MODIFICATION INSTRUCTIONS **for the**

***Kodak X-Omat* MULTILOADER 300**
Modification No. 37

***Kodak X-Omat* 270 RA PROCESSOR**
Modification No. 22

***Kodak X-Omat* 180 LP and 180 LPS PROCESSORS**
Modification No. 9

FIXER/WASH CROSSOVER - Drive Side

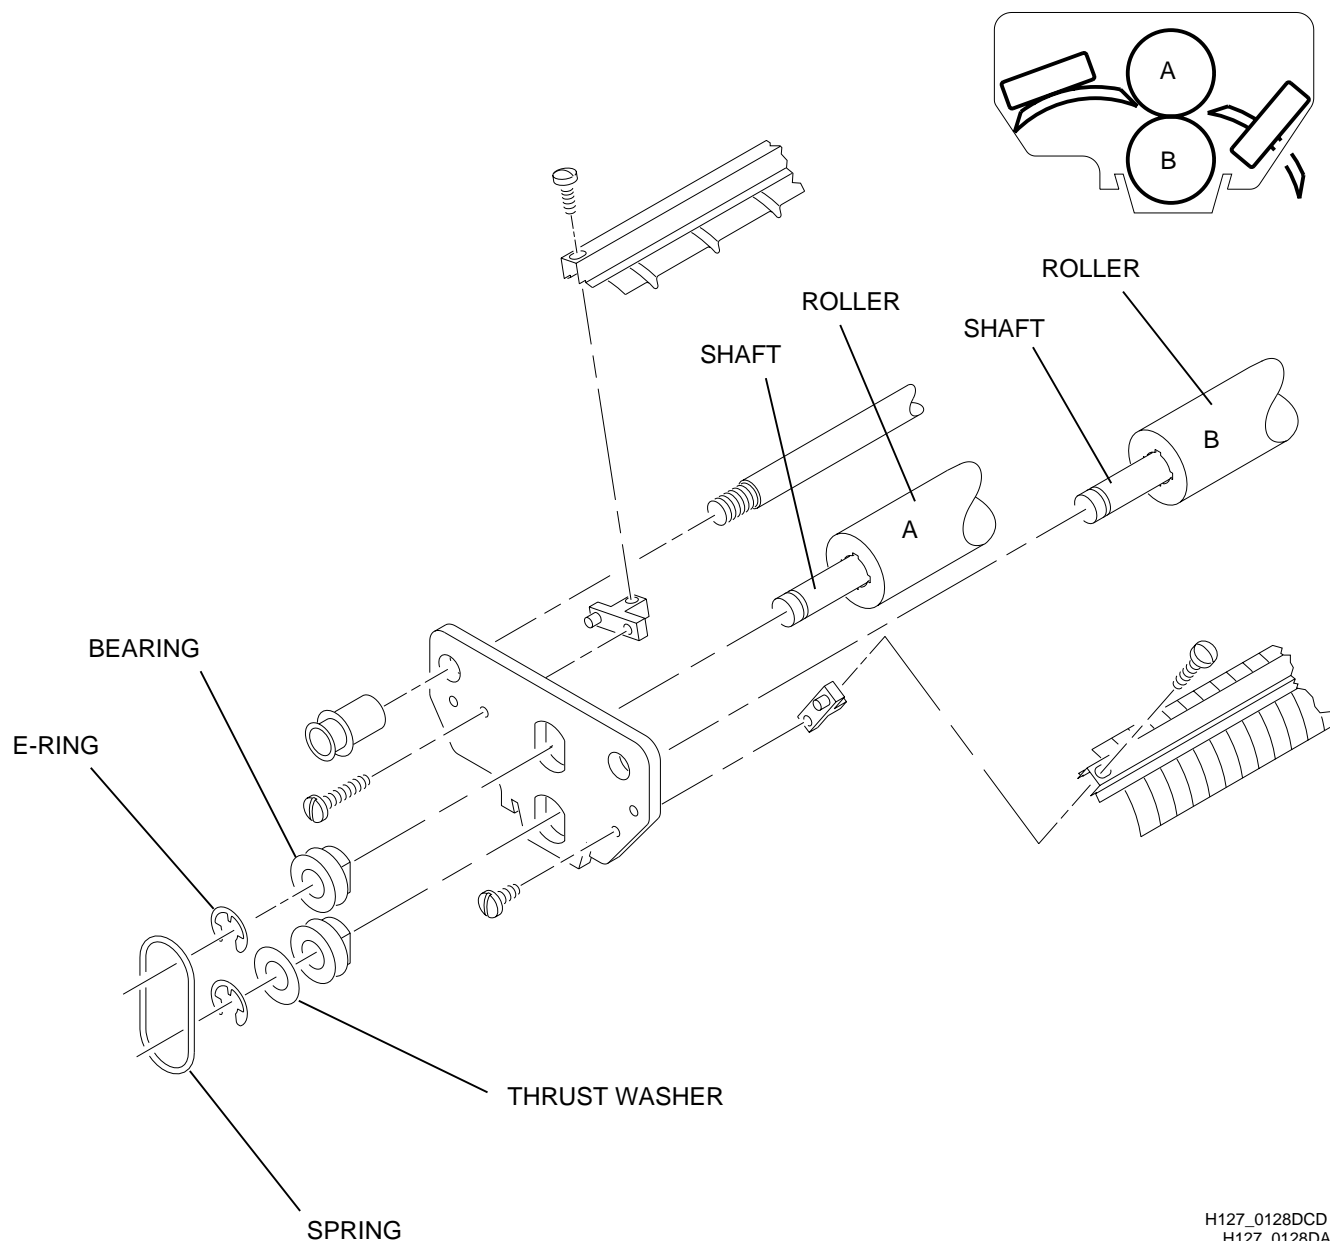
Purpose: To increase the reliability of the PROCESSOR by replacing the ROLLERS in the FIXER/WASH CROSSOVER. The replacement phenolic ROLLER has a steel core, which significantly reduces swelling, binding, and possible film transport problems. The mating rubber ROLLER is being replaced because the new ROLLERS are not interchangeable with the existing ROLLERS, and therefore must be replaced as a set. New BEARINGS and E-RINGS are also supplied.

1. Remove the FIXER/WASH CROSSOVER from the PROCESSOR
2. Remove the TROUGH, and save.
3. Remove the existing ROLLERS, BEARINGS, and E-RINGS, and discard. Save the SPRINGS, SHAFTS, and THRUST WASHERS.
4. Install the new ROLLERS, BEARINGS, and E-RINGS from the Mod Kit, using the SPRINGS, SHAFTS, and THRUST WASHERS saved in the previous step. Make sure that the THRUST WASHERS and other parts are assembled in the order shown.
5. Install the TROUGH.
6. Check the squareness of the RACK on a smooth, flat surface.
7. Install the FIXER/WASH CROSSOVER in the PROCESSOR.

Description	Old Part No.	New Part No.
Roller, Drive (black, rubber) [B]	594237	470085
Roller, Driven (phenolic) [A]	911660	9B8662
Fixer/Wash Crossover Assembly	918945	9B8445
